DART AEROSPACE LTD		Work Order:	119714
Description: Crosstube High Aft (205/212)		Part Number:	D212-664-201
Inspection Dwg: D212-664-241 Rev: D		Page 1 of 1

DRAWING NO. D212-664-241
TITLE CROSSTUBE ASS'Y (205/212 HI AFT)

DRAWING NO. D212-664-241	TITLE CROSSTUBE ASSY (205/212 HI AFT)	REV. D	DART AEROSPACE LTD ENGINEERING ORDER		D.E.O. NO. D212-664-241-D-1	SHEET NO. SHEET 1 OF 2	SCALE NTS
DRAWN	CHECKED	MFG. APPR.	APPROVED	DE APPR.			
DATE 11.04.07	DATE 11.04.11	DATE 11.04.12	DATE 11/04/12	DATE 11.04.12

DRAWING NO. D212-664-241	TITLE CROSSTUBE ASS'Y (205/212 HI AFT)	REV. D	DART AEROSPACE LTD ENGINEERING ORDER		D.E.O. NO. D212-664-241-D-2	SHEET NO. SHEET 1 OF 1	SCALE NTS
DRAWN <i>q</i>	CHECKED <i>ASS</i>	MFG. APPR. <i>B</i>	APPROVED <i>MD</i>	DE APPR. <i>HA</i>			
DATE 11.07.15	DATE 11.07.20	DATE 11.07.21	DATE 11.07.21	DATE 11.07.21

**D212-664-241/-241B
ASSEMBLY DETAIL**

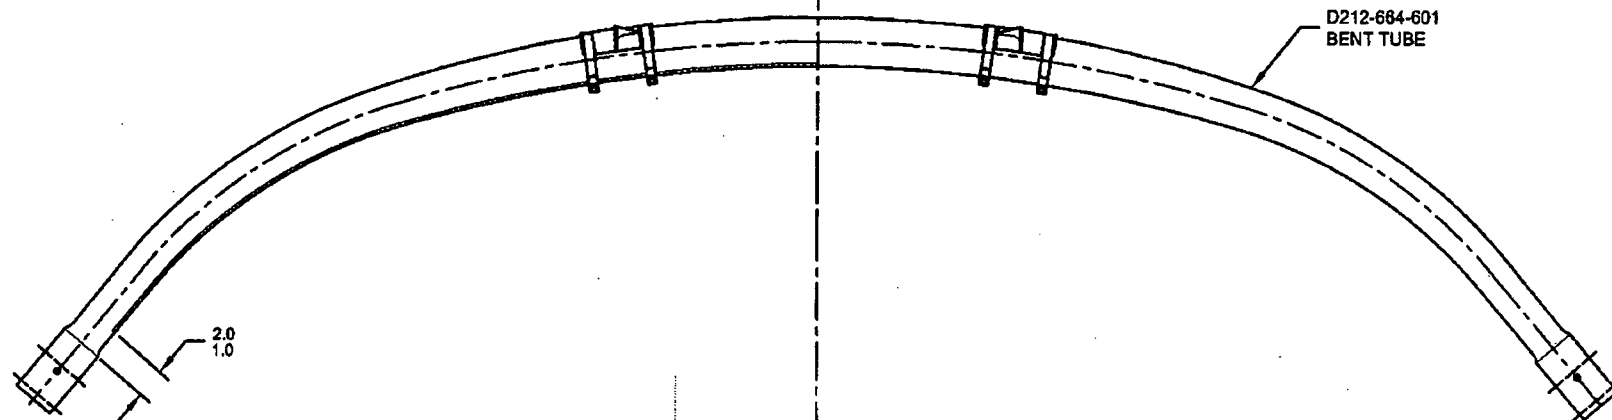
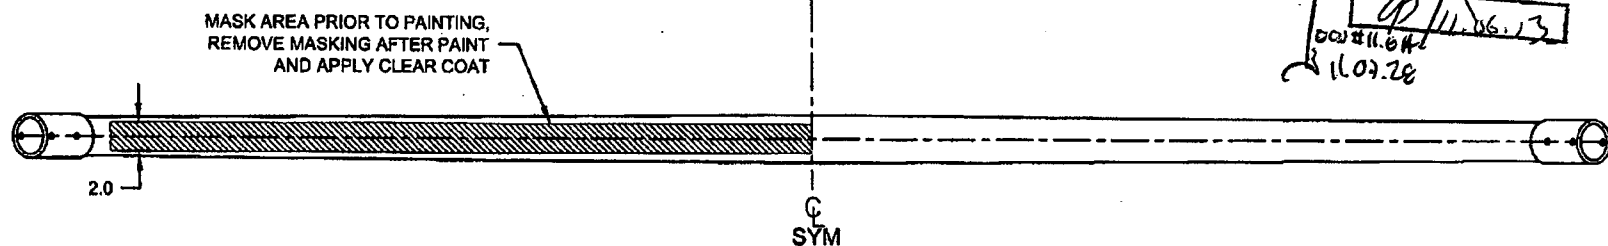
PURPOSE:

ADD AN INSPECTION WINDOW TO UNDERSIDE OF CROSSTUBE.

CHANGE:

NOTES 2 OF SHEET 1 IS AMENDED AS FOLLOWS:

IS:

- 2) FINISH: CHEMICAL CONVERSION COAT PER DART QSI 005 4.1
PRIME INSIDE AND OUTSIDE PER DART QSI 005 4.2
MASK UNDERSIDE OF CROSSTUBE AS SHOWN (HATCHED AREA) AND
PAINT OUTSIDE PER DART QSI 005 4.2
REMOVE MASKING AND APPLY CLEAR COAT

WAS:

- 2) FINISH: CHEMICAL CONVERSION COAT PER DART QSI 005 4.1
PRIME INSIDE AND OUTSIDE PER DART QSI 005 4.2
PAINT OUTSIDE PER DART QSI 005 4.2

FIGURE 1: SUPPORT INSTALLATION

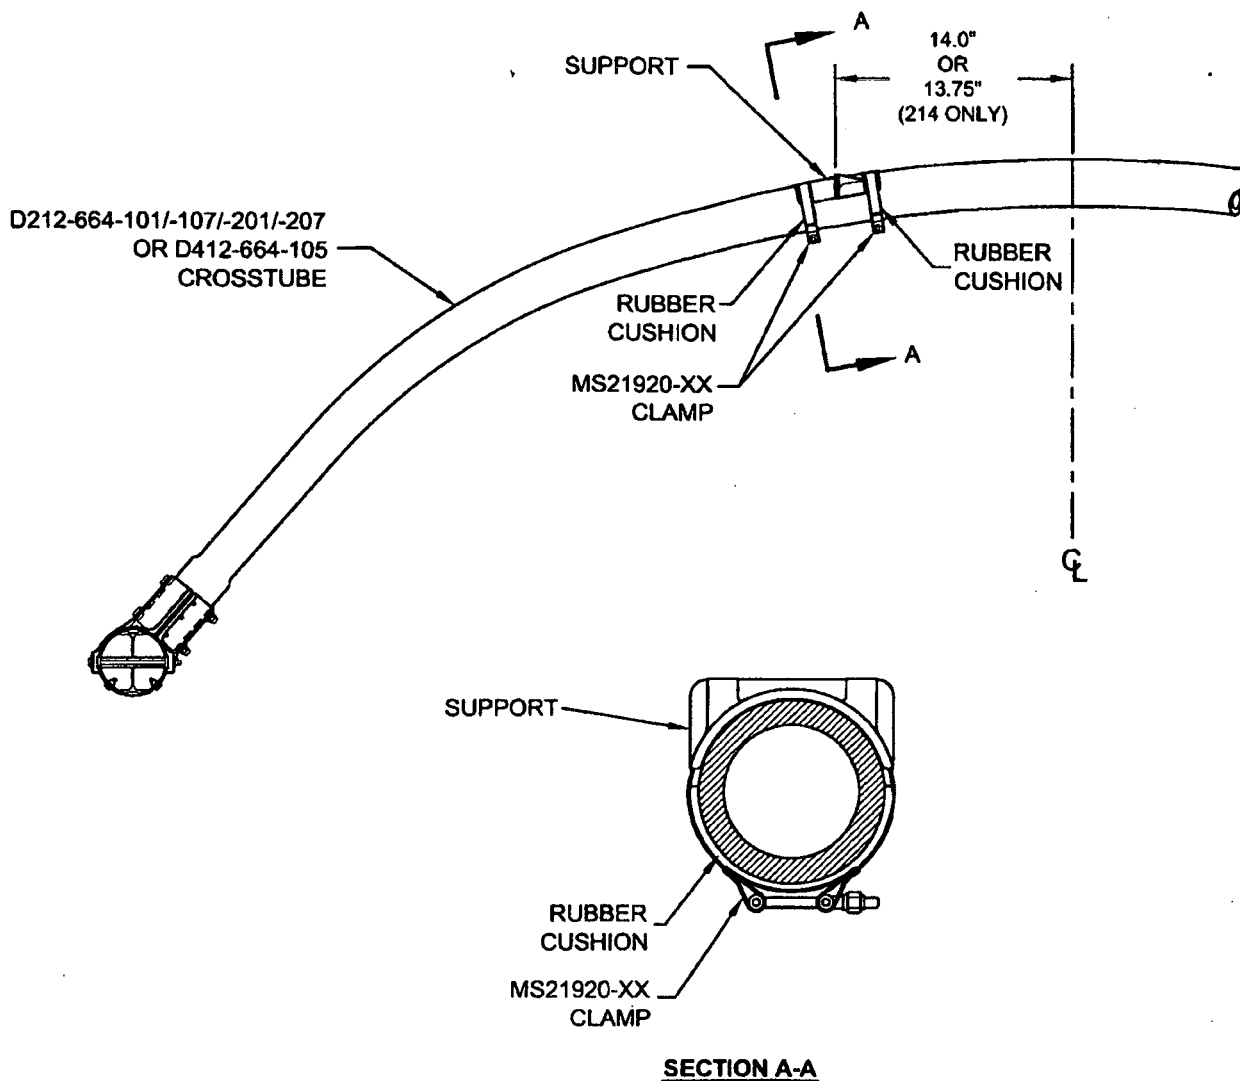
PURPOSE:

The supports on the following crosstubes are now installed using Proseal instead of Magnobond:

For the crosstubes listed above, section 32.4 of ICA-D212-664 is amended as follows. Use Figure 1 of this service instruction and Figures 32-2 to 32-9 of ICA-D212-664 for further reference. For crosstubes of an earlier change number, it is recommended that if the supports are removed, the supports should be reinstalled using the procedure listed below.

- 32.4.1 Locate the area on the crosstube for installation of support (see Figure 1 of this service instruction). For D212-664-101/-107/-201/-207 and D412-664-105 crosstubes, the outward face of the support tabs should be 14.0" (355mm) from the crosstube center for 204/205/210/412/UH-1 aircraft. For installation on 214B/B-1 aircraft, the outward face of the support tabs should be 13.75" (349mm). Ensure paint finish of crosstube is intact; touch up as required per Chapter 5 (5.3.9) of ICA-D212-664.

- 32.4.5 Apply a 0.04" to 0.07" thick layer of Proseal 890 Class B or AMS-S-8802 Class B sealant underneath applicable support and install support as shown in Figure 1 of this service instruction.

- 32.4.6 Install the clamps opposite to crosstube support as shown in section A-A of Figure 1. Install rubber cushions underneath each clamp around the bottom circumference of the crosstube up to the crosstube centerline. Torque clamps 80-100 in-lb (9.0-11.3 Nm). It is acceptable to use smaller or larger sized MS21920-XX clamps than those listed in ICA-D212-664, ensure that after torquing the clamps per this instruction, the nuts are in safety but not bottomed out

- 32.4.7 Prior to installing crosstube on aircraft, allow supports to cure for 72 hours and recheck torque on clamps.
